BOARD OF ZONING ADJUSTMENT
APPLICATION NO. 16987

REPORT OF PARTIES OPPONENT
CONCERNING LINEAR AND AREA MEASUREMENTS
AND OTHER CHARACTERISTICS AS THEY RELATE TO ZONING REQUIREMENTS

Applicant Pablo Martinez seeks a special exception under 11DCMR 3104.1 from the area requirements of 11DCMR Sections 403, 404, and 406, to allow a rear deck addition to an existing flat (two-family dwelling) in an R-4 District at 1207 Clifton St., N.W. (Square 2865, Lot 41). Dimensions provided by the applicant and by the D.C. Office of Planning are inaccurate, incomplete, and / or misleading (for example, the Office of Planning states that the deck addition is nine feet above grade, neglecting to mention that the height referred to is for the floor of the deck, but that the railings rise almost another four feet above that, and that the height is in fact as much as fourteen feet above grade at the alley).

PLAT

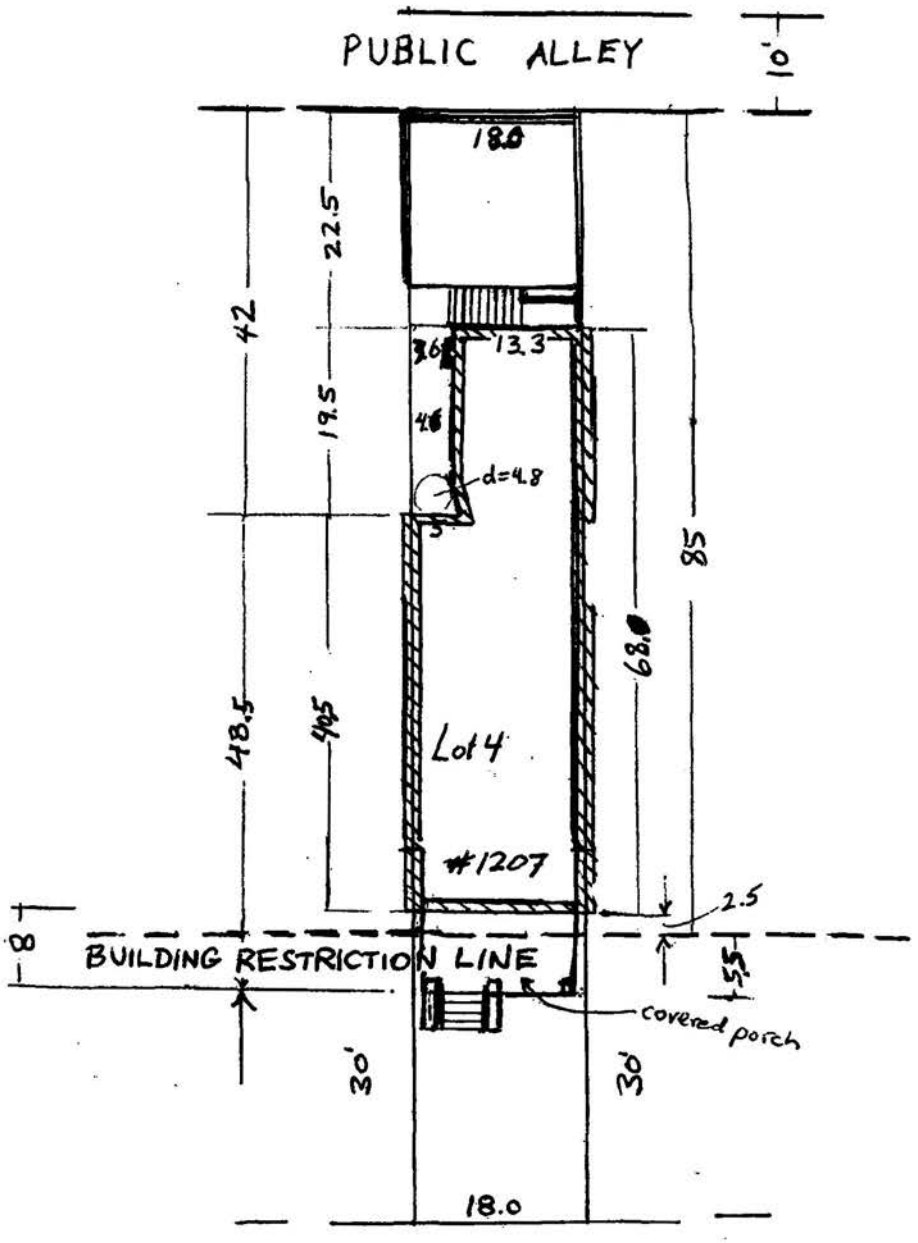
2) open courts less than 5 feet (5') in width and closed courts less than 6 feet (6') in width, per 11 DCMR §199 definitions of "building area" and "percentage of lot occupancy;" notably the closed court (width: 3.6' [or 4.8' if considered non-rectangular]; area: 110 sq. ft.) between the building and the west lot line;

1) the applicant's plat shows a setback of the front porch of approximately two feet inside the (dashed) building restriction line. The parties opponent contend that the covered front porch actually extends 5.5 ft. beyond the building restriction line, and that the 4.5 foot high masonry buttresses extend another 4 feet beyond that, for a total projection beyond the building restriction line of 9.5 feet.

2) the applicant's plat shows a five foot wide court, while his accompanying plans show (in Plan Sheet A) a court width (for the same court) which, based on the indicated [3/8"=1'-0"] scale, appears to be less than three feet, thus impeaching his signed certification on the face of the plat and therewith the reliability of all of his plans, drawings, and dimensions;

Photographic Exhibits

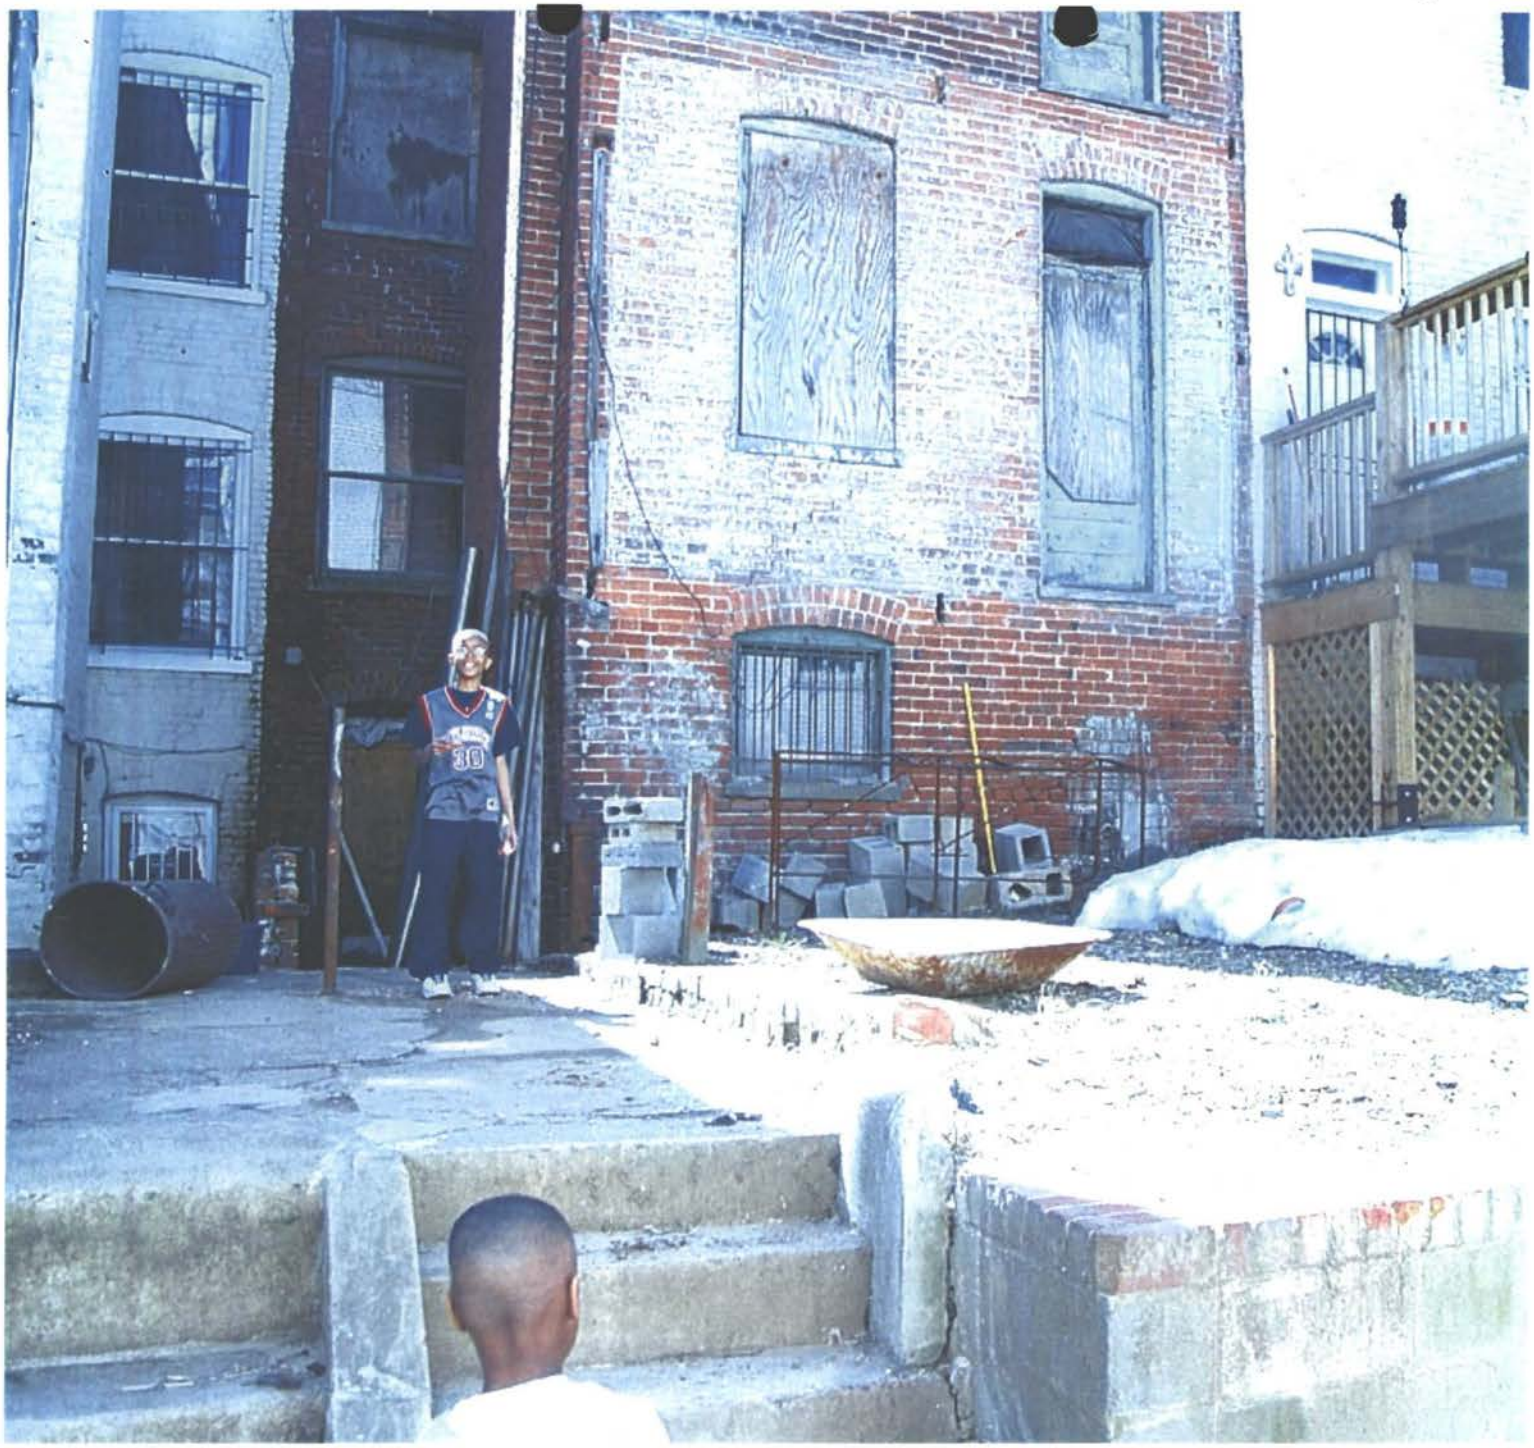
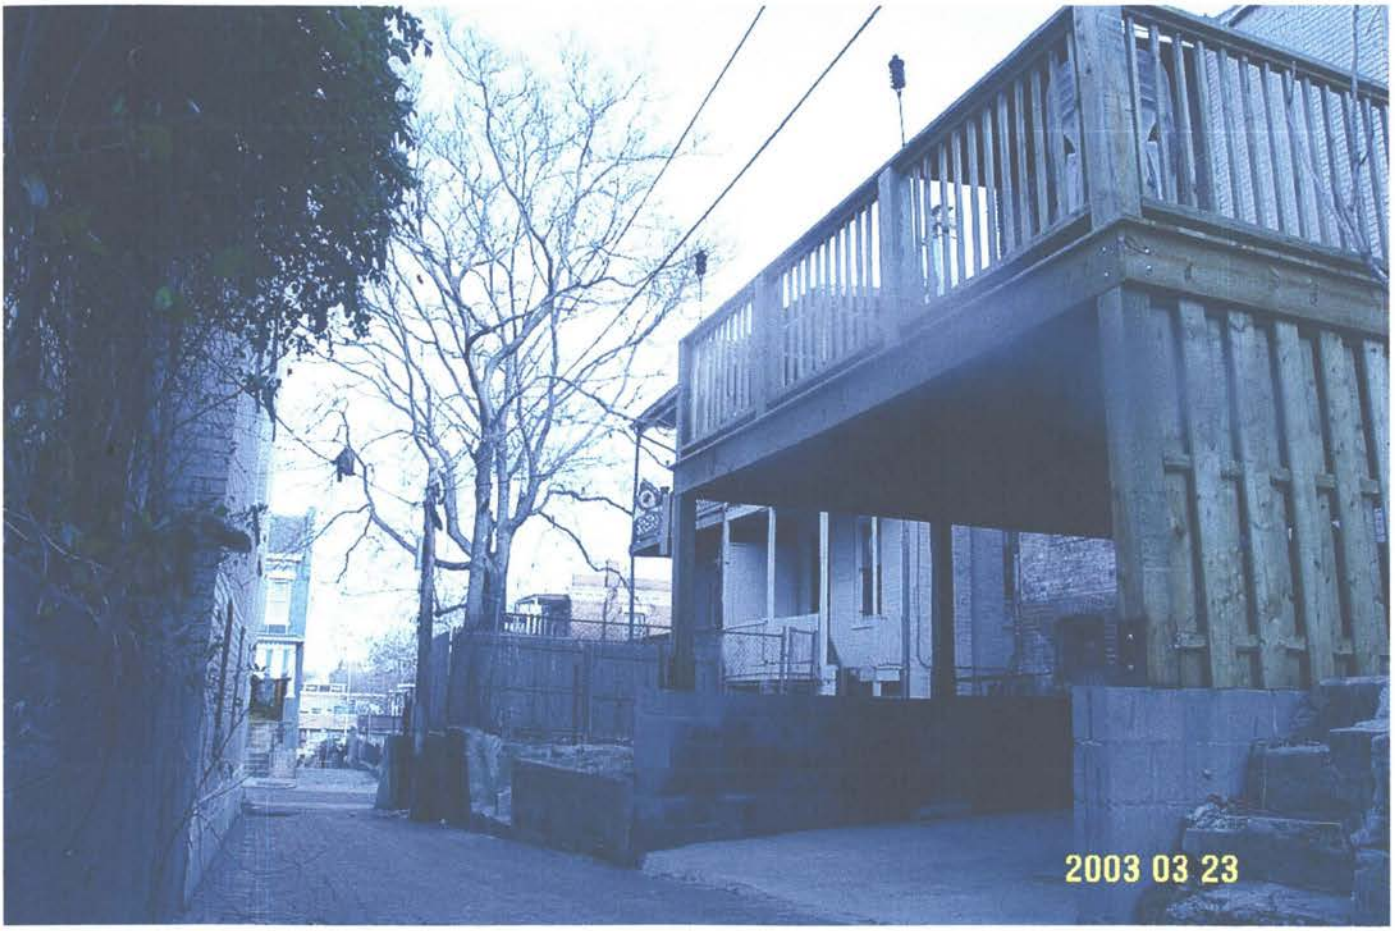
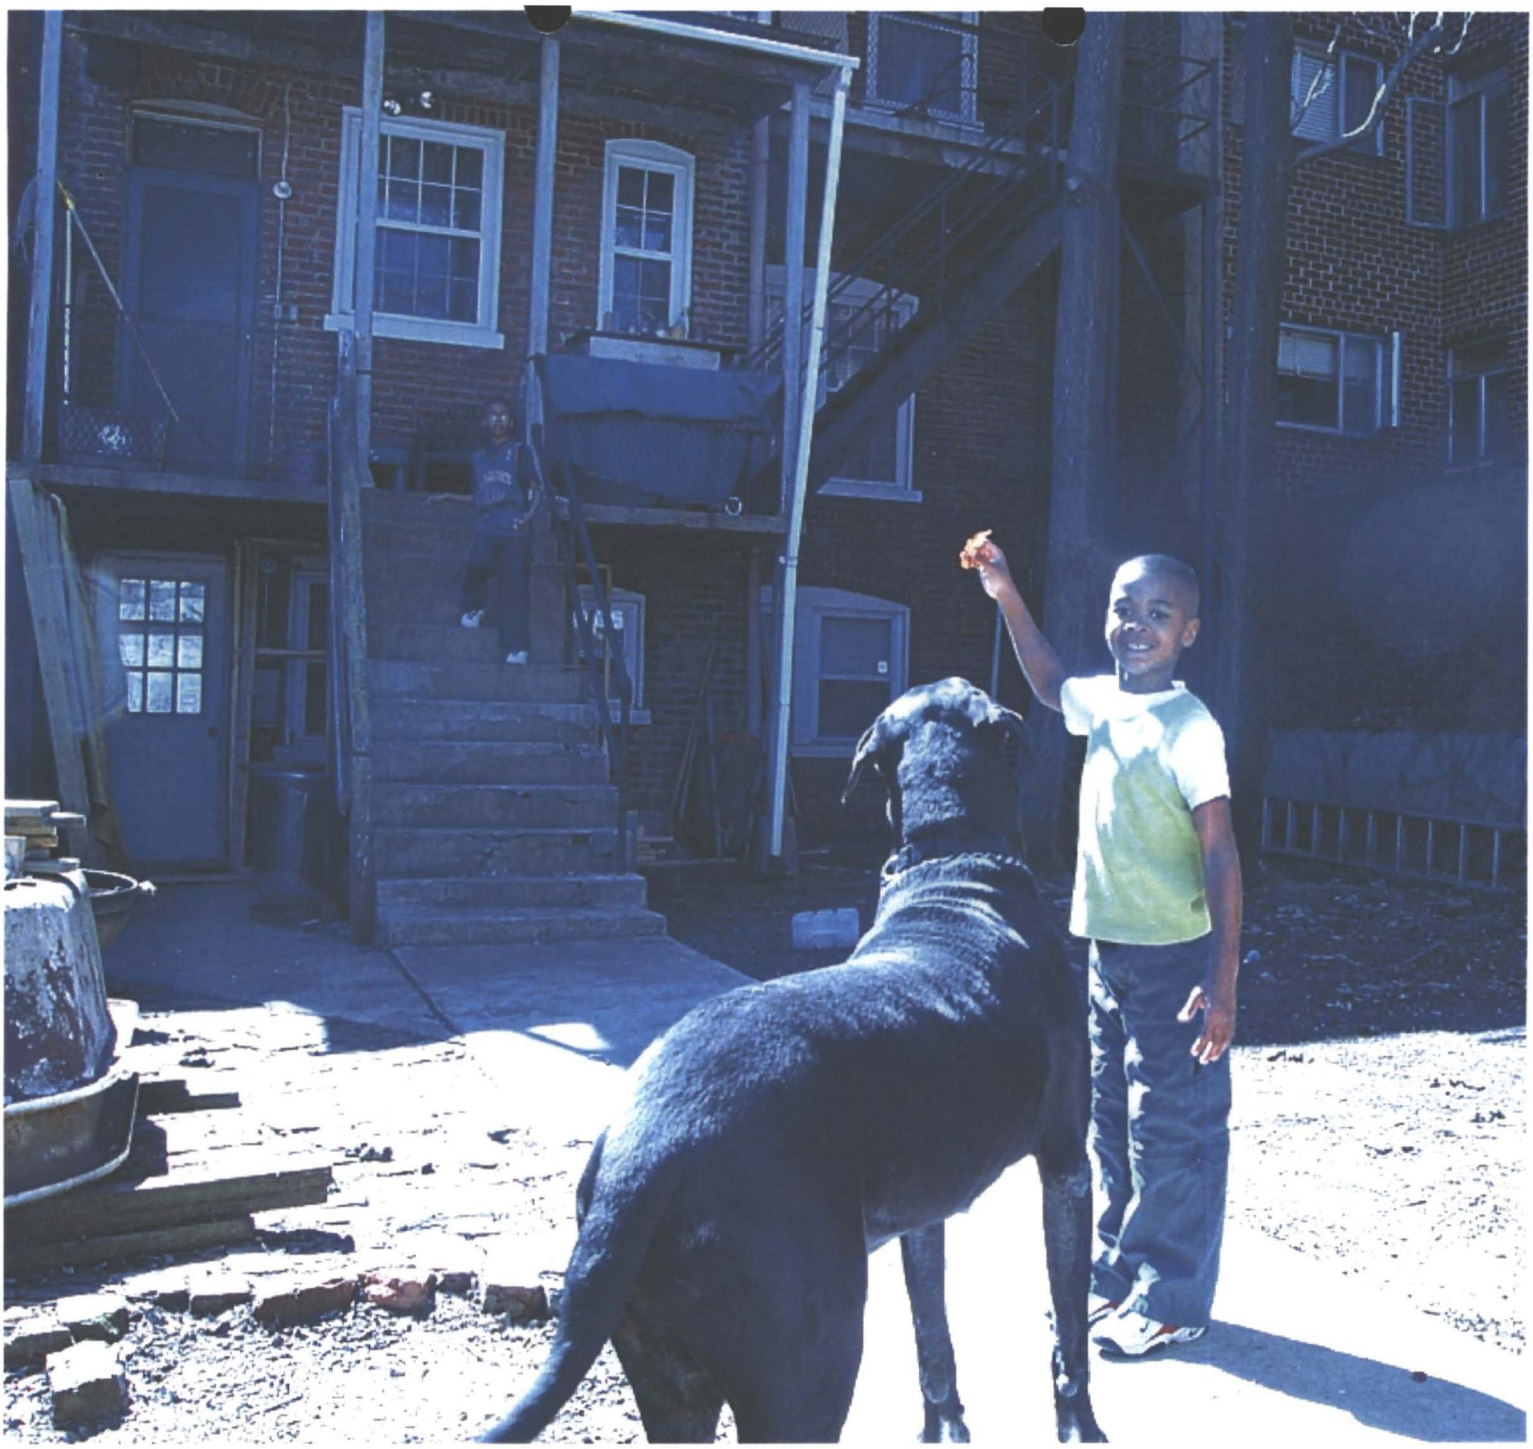
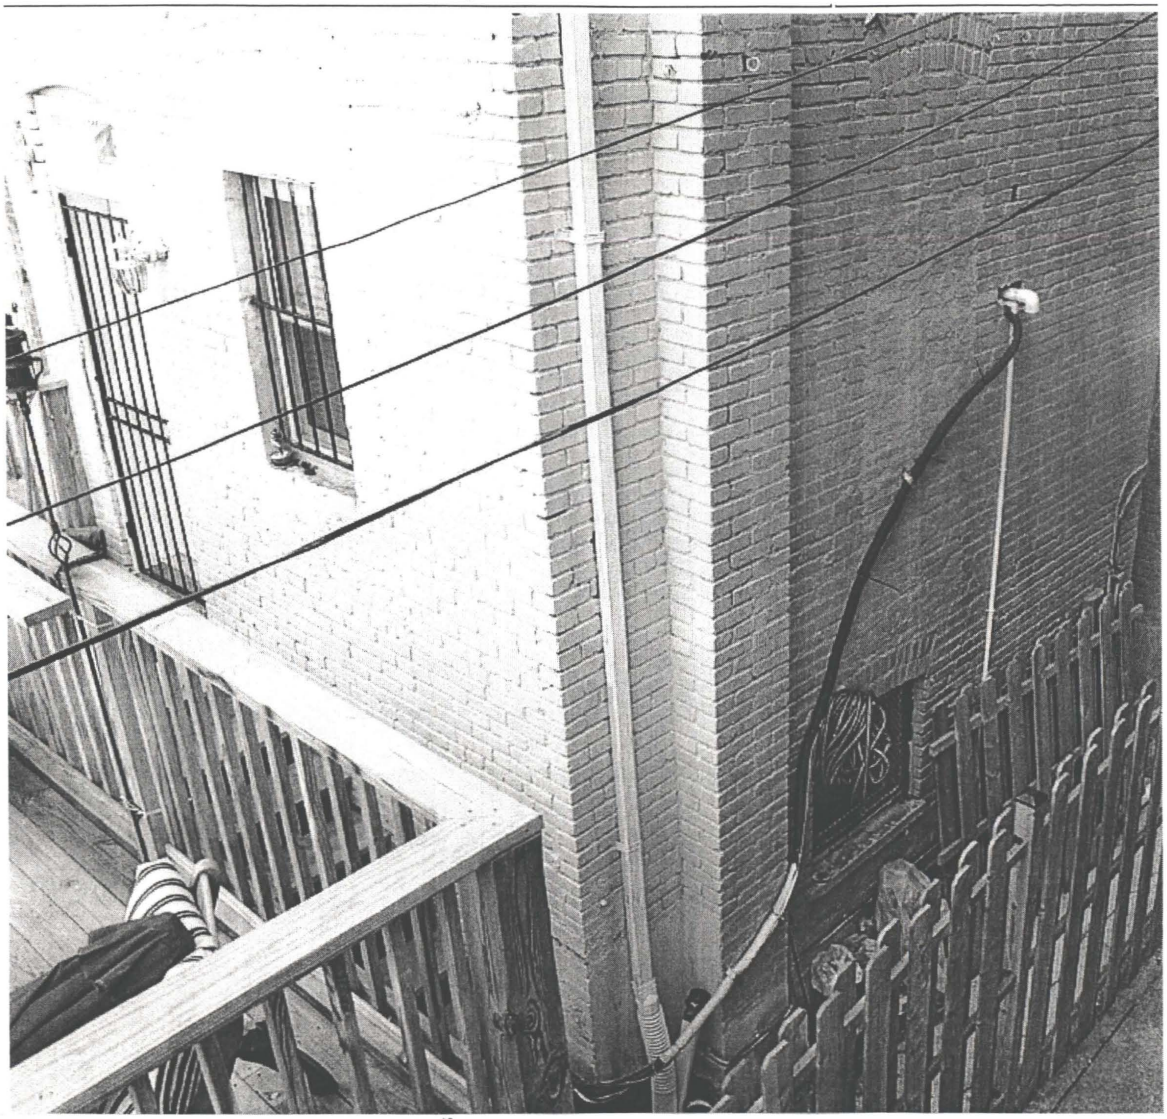
D. Deck addition occupying former rear yard of 1207 Clifton St., viewed from alley looking east toward 12th St.; note scale and contrast with open rear yards of 1201, 1203, and 1205 Clifton St. (at lower right)

E. Party opponent Robert Stofferson (approx. 6 feet tall) dwarfed by 1207 Clifton St. deck addition

F. Deck addition to 1207 Clifton St., viewed from alley looking east toward 12th St., showing visual intrusion upon character, pattern, and scale of houses along subject street frontage (open rear yards of [from left] 1201, 1203, and 1205 Clifton St., respectively, are to left of subject deck addition)

H. Deck addition to 1207 Clifton St., viewed from 1205 Clifton St. rear yard at alley; note elevation of main deck structure above main floor level of house

J. Deck addition to 1207 Clifton St. overlooking and thereby defeating "privacy fence," viewed from rear yard of 1209 Clifton St. at alley

K. Deck addition to 1207 Clifton St. overlooking "privacy fence" into 1209 Clifton St. rear yard and house, viewed from 1209 Clifton St. 1st floor window

L. Deck addition to 1207 Clifton St. overlooking "privacy fence" into 1209 Clifton St. rear yard and house, viewed from 1209 Clifton St. 2nd floor window
